**Pepperdine University Campus Life Project
Draft Environmental Impact Report
SCH# 2008041123**

Responses to Comments from Santa Monica Mountains Conservancy

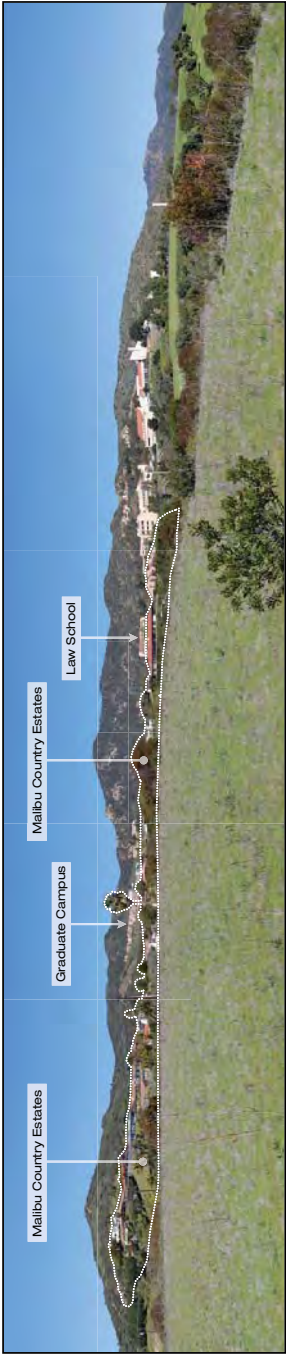
The elevation of the NCAA soccer field would be approximately 10 feet higher than the level of the existing track and field (DEIR, p. 5.11-39). The tops of the light standards would be visible from a 1,300-foot-long stretch of Pacific Coast Highway (PCH), a scenic highway (DEIR, p. 1-62).) At the Enhanced Recreation Area (Component Area 5), lighting would be replaced and the new lighting consists of six 80-ft.-tall lighting standards (DEIR, p. 5.3-37). The DEIR (p. 5.7-28) states that for the Enhanced Recreation Area the tops of the poles (approximately the top 20 feet of the poles) may be seen from the central of the three proposed camping sites (at Malibu Bluffs Park). The tops of the poles can be seen from distances of 4,750 feet (0.9 mile) and over (DEIR, p. 5.7-28). Even if the bulbs would not be visible from Malibu Bluffs due to the recessed placement of the bulbs within the shielding element (as a Pepperdine representative stated during the site visit), it still seems that Malibu Bluffs campers would be able to see the stream of light below the shielding, but along the portion of the new tall lighting standards that would be visible from Malibu Bluffs. The biology section of the DEIR (p. 5.3-37) states that while contrast, or glare, would increase somewhat at the receptor location within Malibu Bluffs State Park, the distance between the State Park and any of the CLP component sites reduces the likelihood that wildlife would be significantly affected. It is not clear how "more effective shielding and downward angled orientation" would lead to lower illuminance (light trespass) at Malibu Bluffs compared with existing conditions.

None of the light poles proposed for the Upgraded NCAA Soccer Field, Enhanced Recreation Area, and related baseball lights project would be visible from the two Camping Areas (1 and 2), located west of the John Tyler Drive/PCH intersection. This is due to the fact that the lines of sight connecting these Camping Areas to the Upgraded NCAA Soccer Field and Enhanced Recreation Area components pass over and are obstructed by the Malibu Country Estates (“MCE”) residential subdivision. The elevations and structural elements of MCE homes, topography and mature landscaping combine to reach elevations that effectively block potential views of the light poles proposed for the Upgraded NCAA Soccer Field, the Enhanced Recreation Area, and the related baseball lights project (see **Figures 4 and 5**). The obstruction of views applies to the campsites in Camping Area 2a, which are located near John Tyler Drive and PCH and have a higher potential for views of the CLP and related projects (see Figure 4, Profile A). A second terrain view profile, represents a line-of-sight cross-section from the southern-most campsite in Camping Area 1 and it illustrates the distances between the campgrounds and proposed CLP and related projects as well as the intervening obstructions that block views (see Figure 5, Profile B).

View profile from Camping Area 2A

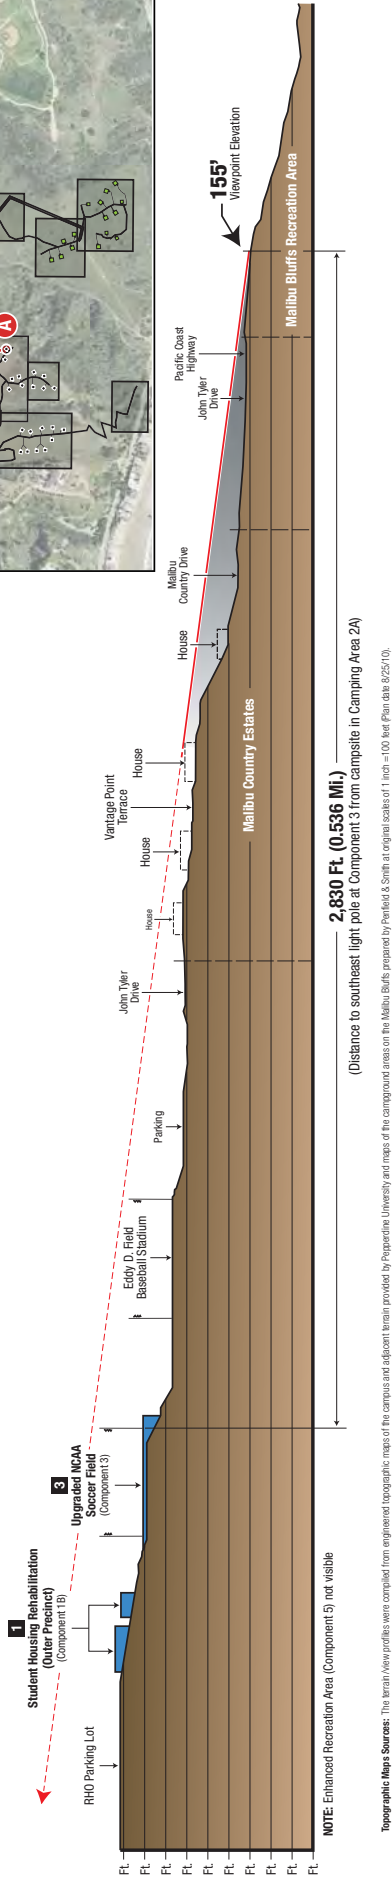
Conservancy Recommendation No. 1: The FEIR should include super-detailed oblique views, including cross sections, of the significant new light sources—the NCAA soccer field and the Enhanced Recreation Area. This would include elevations of these project components, locations and dimensions of new light standards including shielding elements, existing and proposed topographic buffers (e.g., berms), and specifics of tree planting to be used for screening (e.g., locations, species, expected heights after a specified amount of years, etc.). This should be presented in relation to views from Pacific Coast Highway and Conservancy-owned Malibu Bluffs approved camping area(s).

The elevation of Malibu Country Estates intervenes to block visibility of athletics and recreation areas and associated facilities in views from all campsites in Camping Area 2A.

View profile from eastern-most campsite in Camping Area 2A represents potentially the "worst-case" view of athletic field light poles at Component 3.

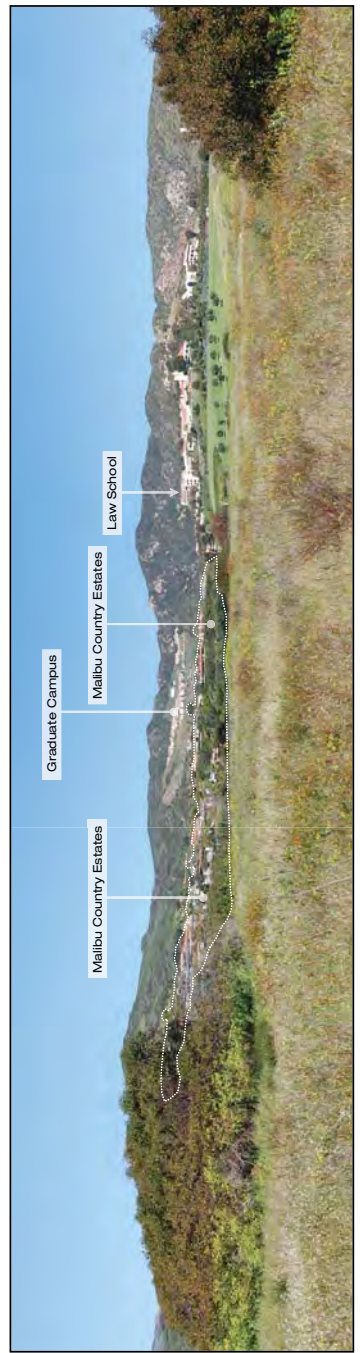
Conservancy Recommendation No. 4: We urge that the FEIR demonstrate that there will be no significant lighting impacts to campsites at the Conservancy-owned Malibu Bluffs from potentially new light sources visible from Malibu Bluffs, as well as from diminished dark sky conditions. We hope that the additional lighting analysis we recommend above will support this demonstration.

See Topical Response 2: Lighting, for a discussion of lighting impacts to Malibu Bluffs, impacts related to sky glow and CLP consistency with dark sky policies and ordinances. As explained therein, and in response to comment SMM-3, the Project has no significant visual impacts on the Bluffs.
